<b>Subject:</b> <b>CREAKING NOISE FROM FRONT LOWER CONTROL ARM BUSHINGS</b>	<b>Bulletin No:</b> 02-005/14
	<b>Last Issued:</b> 12/12/2014

2013-2015 Mazda3

2014-2015 Mazda6

2013-2015 CX-5

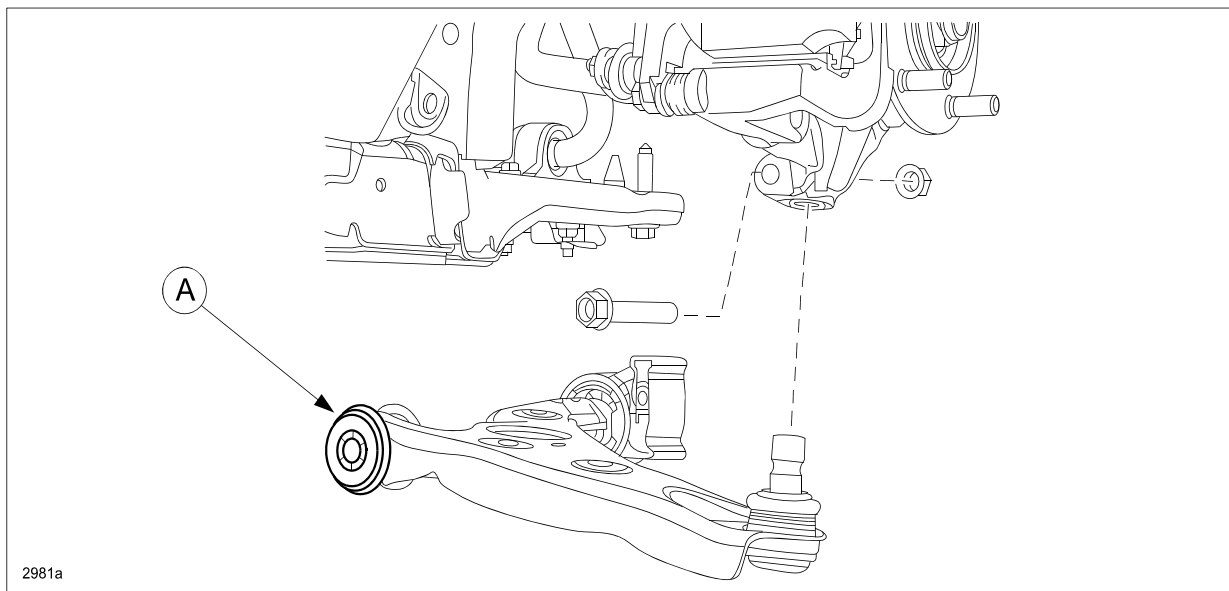
The creaking noise is caused when the front lower control arm bushing(s) (A) become wet.

Customers having this concern should have their vehicle repaired using the following repair procedure.

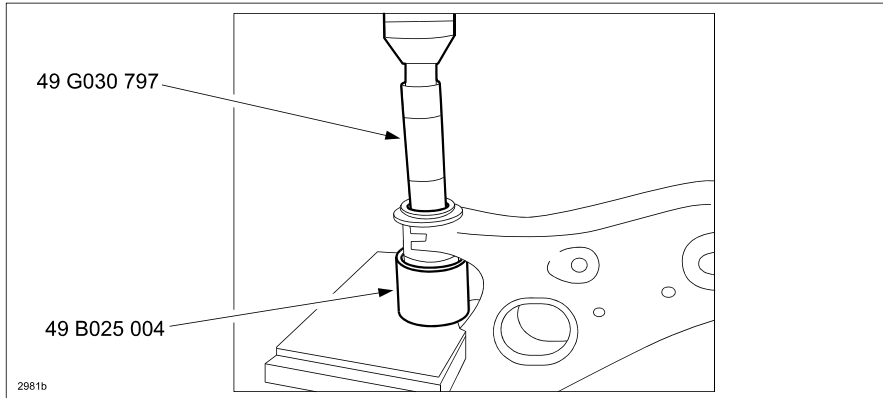
1. If possible, verify the customer concern when driving over bumps under wet conditions.
2. Replace front lower control arm bushing with new service part according to Steps 3 - 8.
3. Remove the front lower control arm according to the on-line instructions on MS3 or the Workshop Manual (section 02-13 FRONT LOWER ARM REMOVAL/INSTALLATION).
4. Remove the front lower arm bushing using SSTs 49 G030 797 and 49 B025 004.
5. Place the SSTs on the front lower control arm as shown below, then press out the bushing.

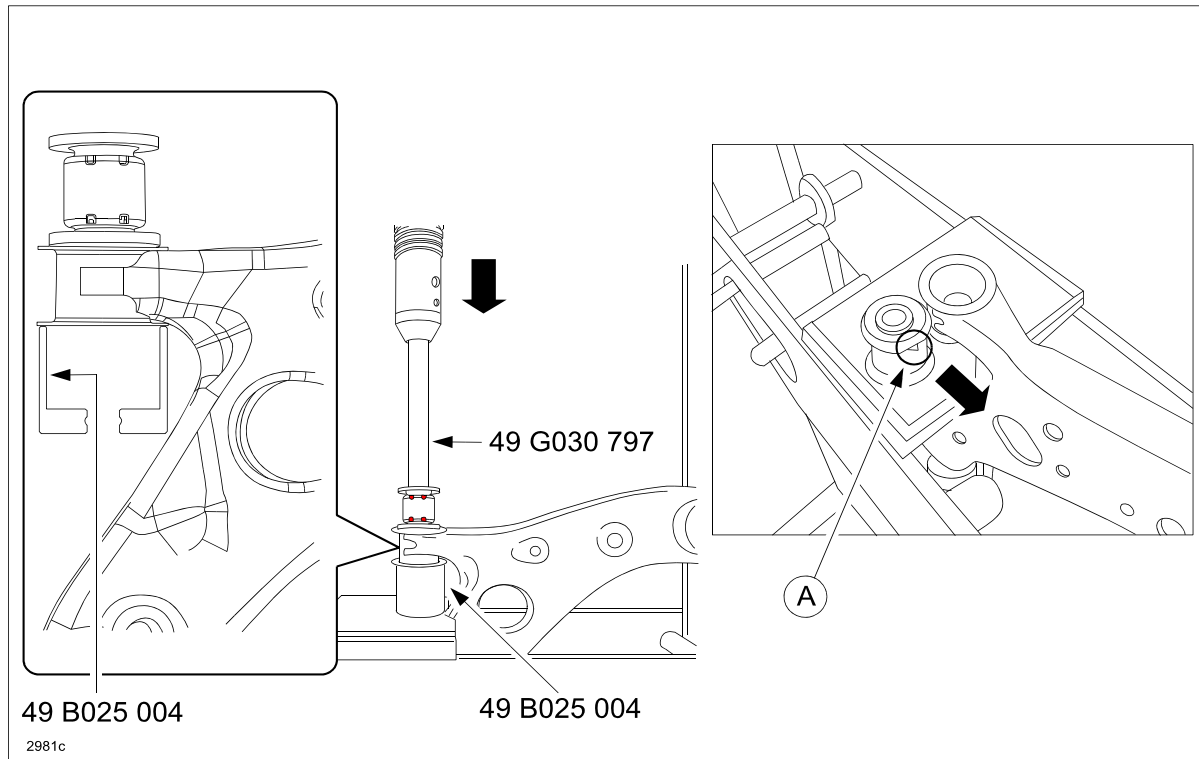
- Apply soap suds to the bushing to ease the installation.
- Always wipe off soap suds from the front lower control arm and bushing with a cloth.
- Install the bushing so the projection (A) is pointing toward the front of the vehicle.

6. Install the modified bushing using the same SSTs.

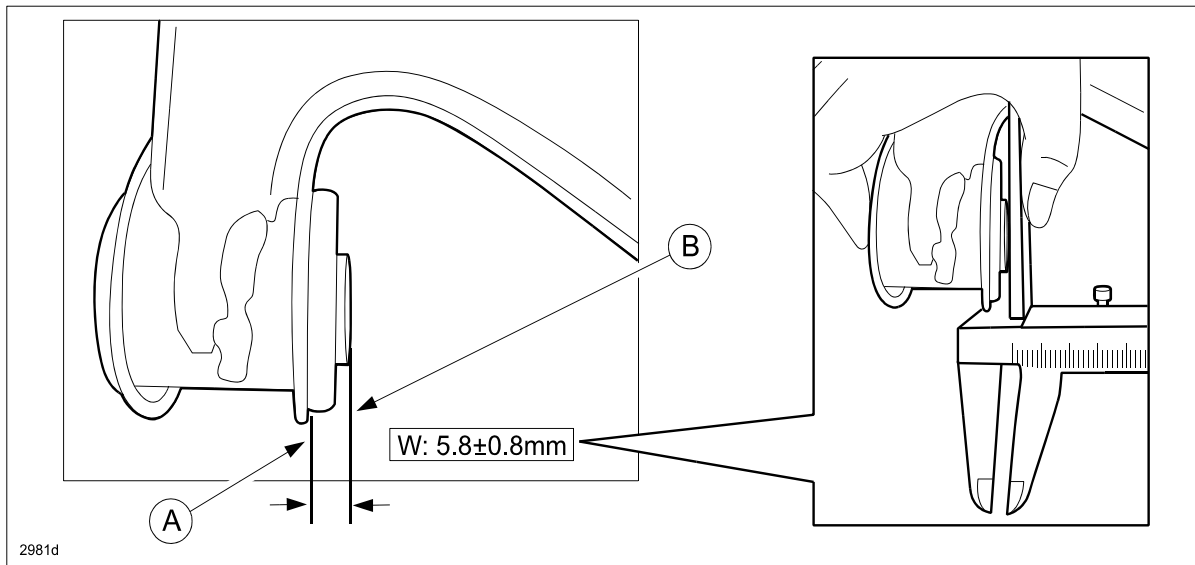
7. After installing the bushing, verify the distance between the front lower control arm (A) and front lower control arm bushing inner pipe (B) equals 5.8 +/- 0.8mm as shown below.
